WEWATTA PLAZA:
DREAMSCAPE
SCULPTURE

ENCROACHMENT PACKAGE

1900 16th Street
Encroachment
Site Plan

Comment Report

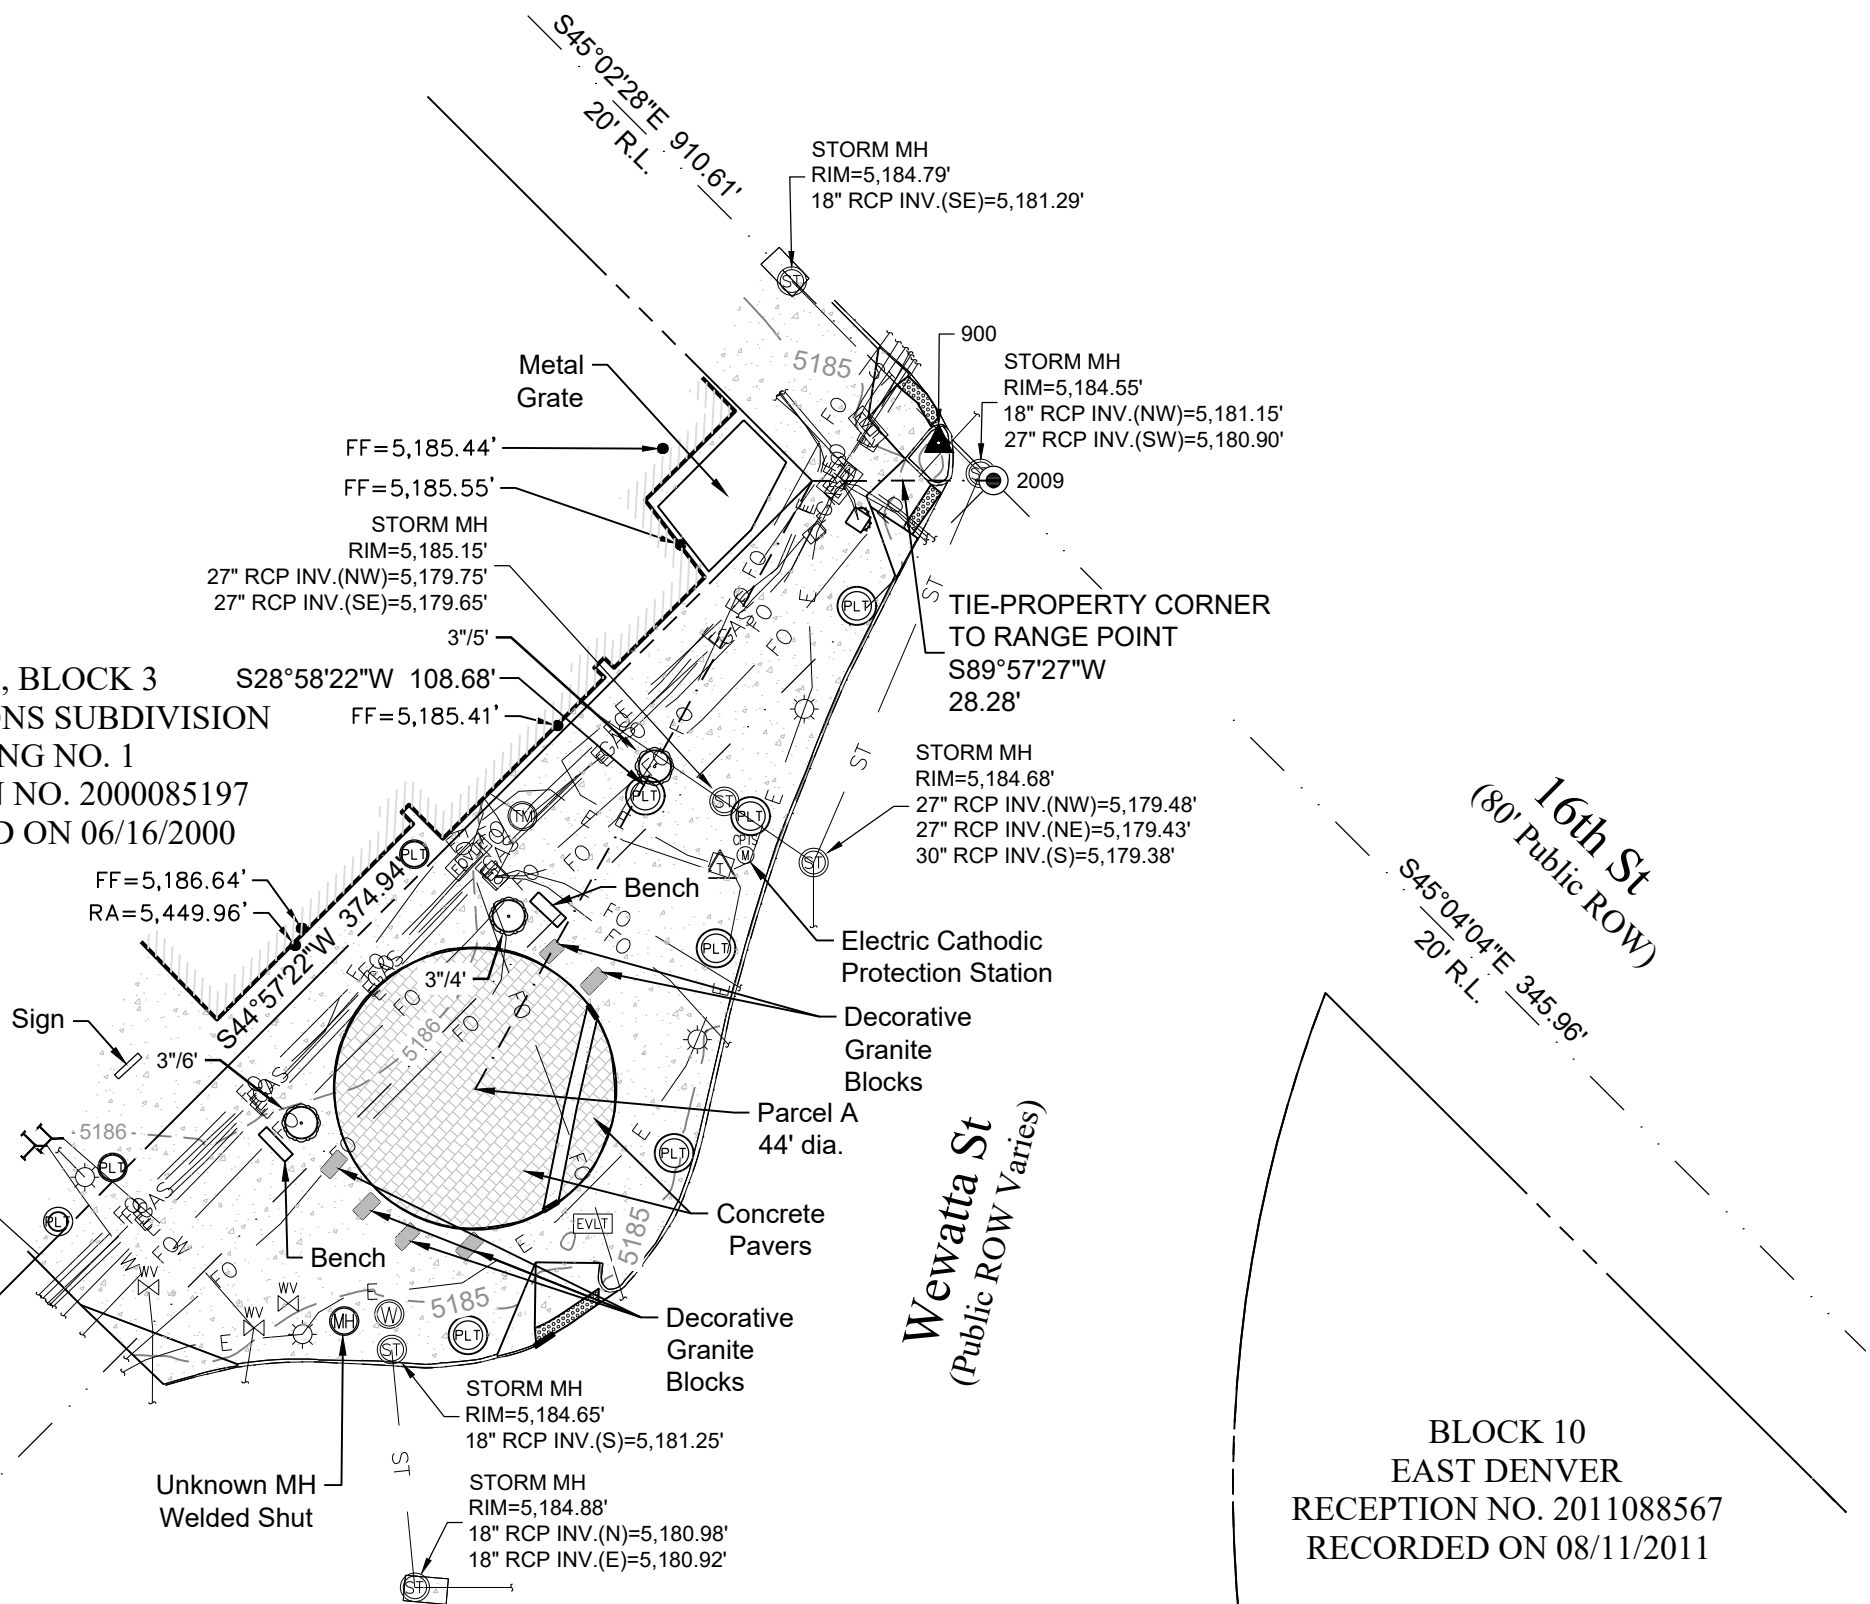
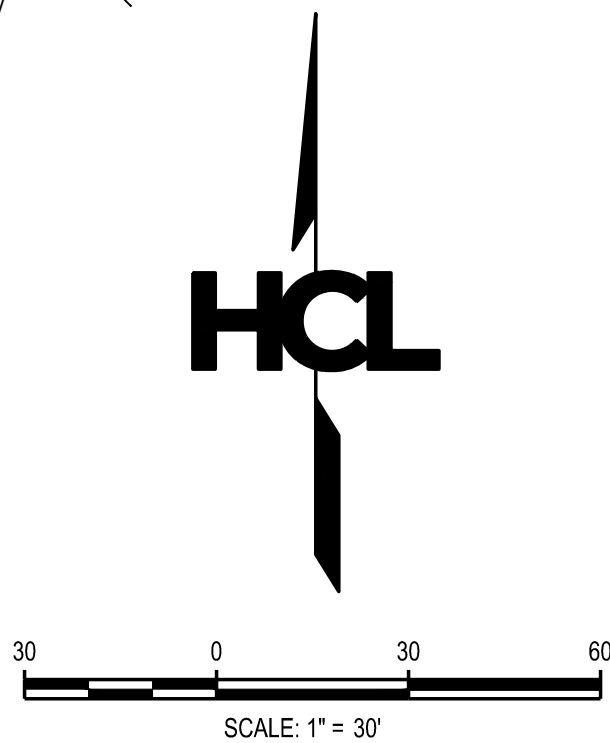
Status Date: 01/14/2026
Status: Denied
Comments: As noted by other reviewers, two large Metro Water Recovery sanitary mains appear to exist under the work area. These should be shown on the design plans, and MWRD approval must be obtained for this work. In addition, CCD GIS data indicates an active sanitary sewer service beneath the work area. This should be investigated to confirm its location/depth and to determine if a conflict exists with the proposed installation. A screen capture of the service line has been uploaded to this Accela record - "2025-ENCROACHMENT-0000162_DSWW_Sanitary Service.png" (also copied to "Comments" folder of internal project folder).

Status Date: 01/12/2026
Status: Denied
Comments:
1. Add dimension(s) from proposed Encroachment(s) to the adjacent flowline.
2. Dimension and label the pedestrian access route (PAR).
3. There are two large MWRD sanitary mains through this location. Show the outer limits of both pipes on the Site Plan. Approval from MWRD is required.
4. It is understood that Metro Districts will only have encroachment legal description and exhibit because there isn't an adjacent property.
5. This application has been forwarded to Arts & Venues. Confirmation from Arts & Venues is required to ensure artwork meets guidelines for artwork in public spaces before permit will be approved.

Status Date: 01/14/2026
Status: Denied
Comments: Show existing 60-inch and 58-inch Metro Water Recover mains and existing sanitary service. Verify application has been reviewed and approved by Metro.

1. Please label all Metro lines and structures within plans so that contractor is aware of when to contact us. Metro owns a 58" RCP pipe that runs through the site.
2. Foundations for the sculpture are being installed on top of or adjacent to Metro's pipe. Please provide profile drawings indicating there will be no conflict.
3. Due to the proximity of the sculpture work adjacent to the 58" sanitary sewer – depending on the methods and equipment used to install the sculpture, Metro may require a pre and post video during work to ensure no damage is done to the existing sanitary line.
2. Include note on future drawings or cover sheet:
 - a. Notify Metro two weeks prior to construction starting at (720-520-1516)
 - b. Notify and invite Metro to the pre-construction meeting at (720-520-1516)

Technical comments have been adequately addressed - see revised site plan attached.
MWRD has status of 'Approved w/Conditions' - applicant working directly with MWRD for requested plan updates.
